**TOWN OF LUNENBURG COUNCIL MEETING MINUTES**

## MEMORANDUM

**RE: BROOK STREET DRAINAGE IMPROVEMENTS**

Drawing showing CSK01 work:

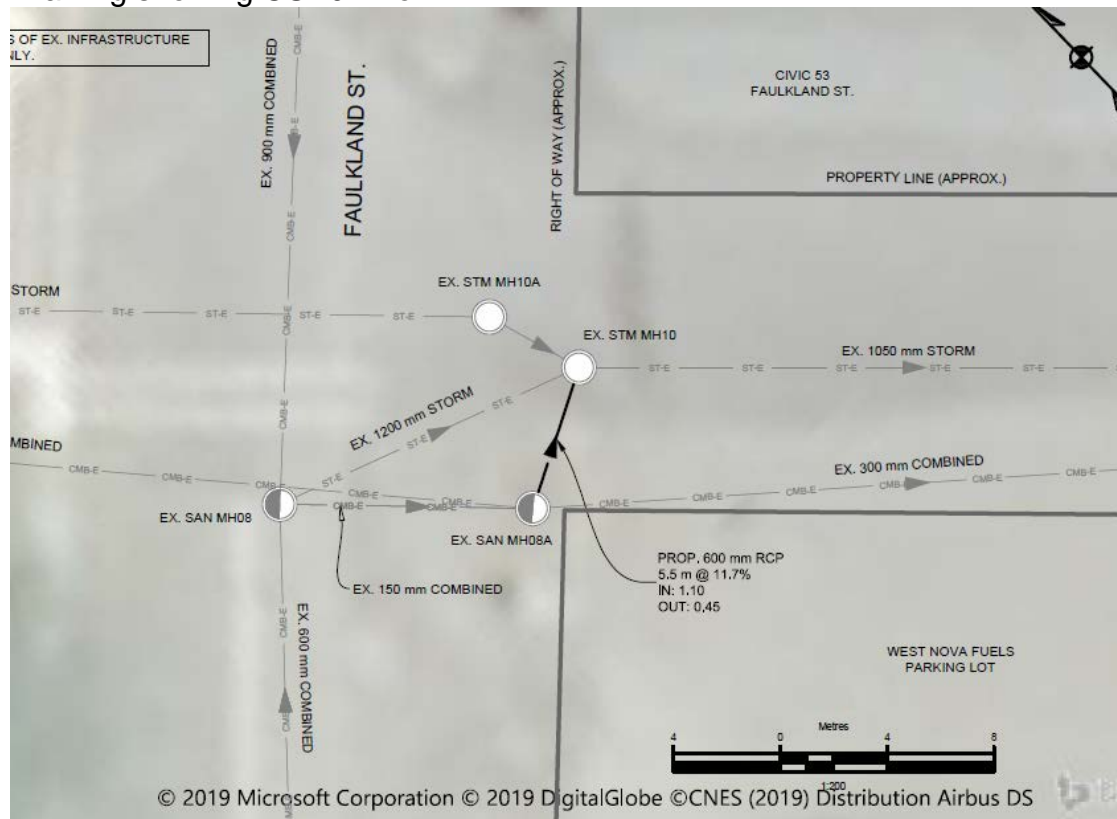
Originally one of the recommendations from the Design Point Report (CSK01 work – which is the installation of an overflow pipe near Brook Street Pump House) was going to be done in-house as it was deemed more cost efficient and a relatively smaller piece of the work that would take the PW crew 3 days or less to complete. However as a result of the COVID situation, this decision was reversed and this scope got added to the tender.

- remove CSK01 work which will now be complete by the PW crew and will be scheduled at a later date in August
- remove the CSK05 work which will have to be differed
- remove the supply of two long lead items, which PW and Procurement have gone ahead and ordered directly from the supplier eventually to be turned over to the contractor
- received a revised submission from the low bidder based on the revised scope. The draft contract has been adjusted to reflect the revised scope and price.

Drawing Showing CSK02 revised work:

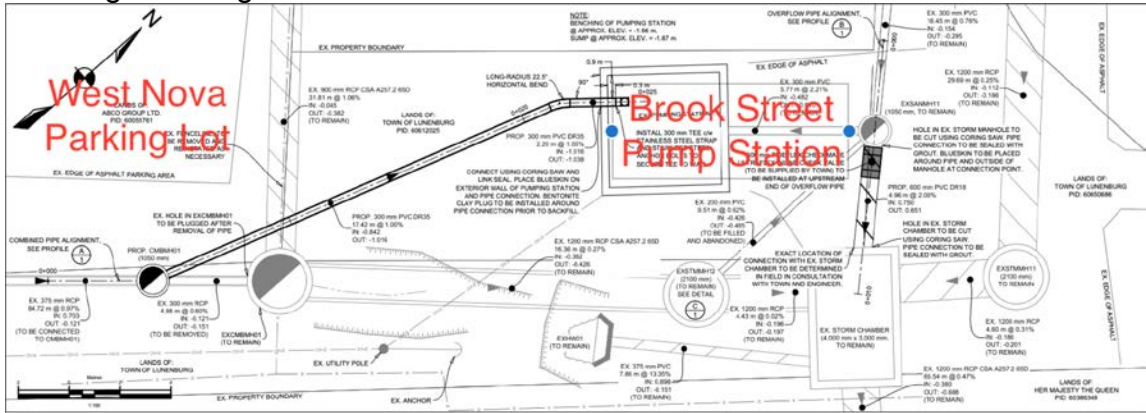
- to include only the critical functional elements from the CSK02 work thereby leaving out some of the elements which are not functional elements but more condition renewal elements such as the re-building of one large catch basin
